Front Brake Pad Wear Sensor Harness Re-routing

Bulletin type: Service Campaign Bulletin
Reference number: 14 C 001
Campaign reference: 041
Attention: Service Managers and Retailer Technicians
Affected vehicles: 720S
Situation: Front brake pad wear sensor harness routed incorrectly.
Procedure: Please refer to the instructions outlined in this document to complete the below checks/rework.
Date: 7th November 2017

Example of the front brake pad wear sensor harness routed incorrectly

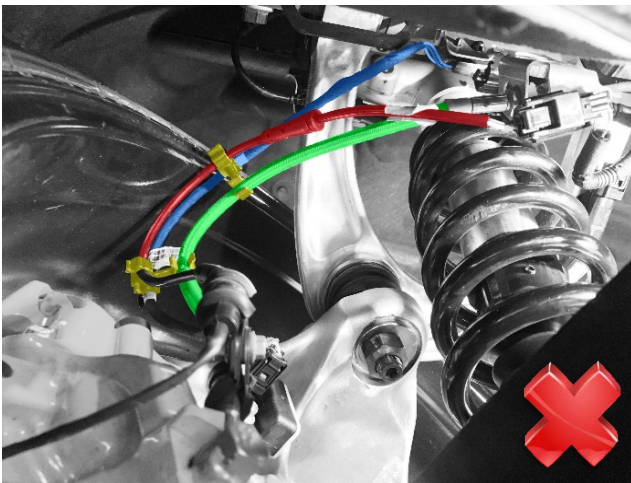
McLaren Automotive has identified that the front brake pad wear sensor harness may be routed incorrectly on some vehicles. This causes it to come into contact with the wheel when the steering wheel is turned on full lock.

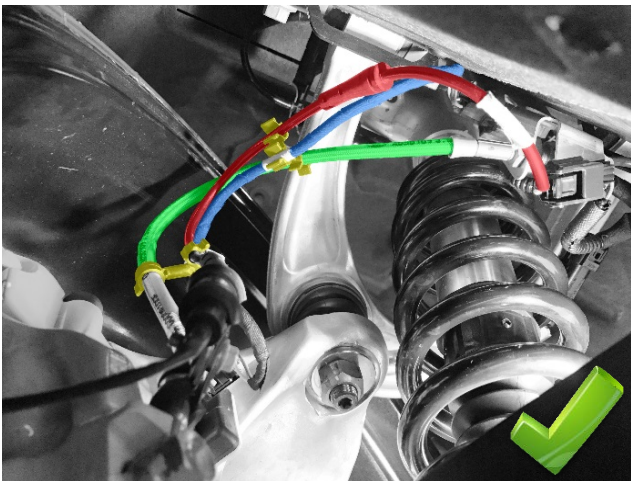
Check the routing of the brake pad wear sensor harness (shown in red).

Incorrect routing: The brake pad wear sensor harness and clip are routed incorrectly, as they are above the brake pipe (shown in green).

Correct routing: The brake pad wear sensor harness and clip are routed correctly, as they are below the brake pipe (shown in green).

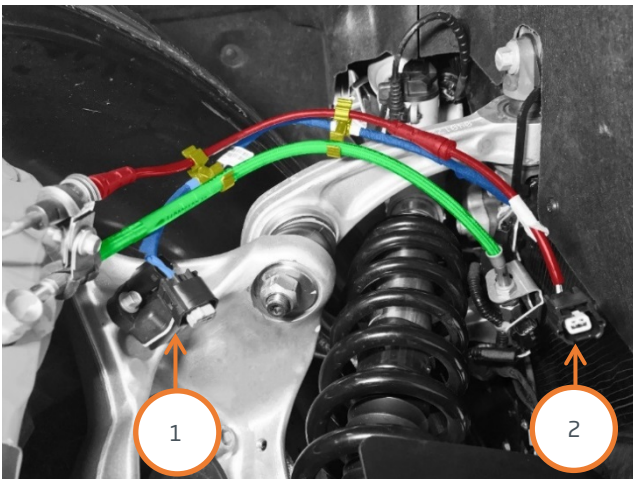
Disconnect the accelerometer sensor connector (1) and the brake pad wear sensor connector (2).
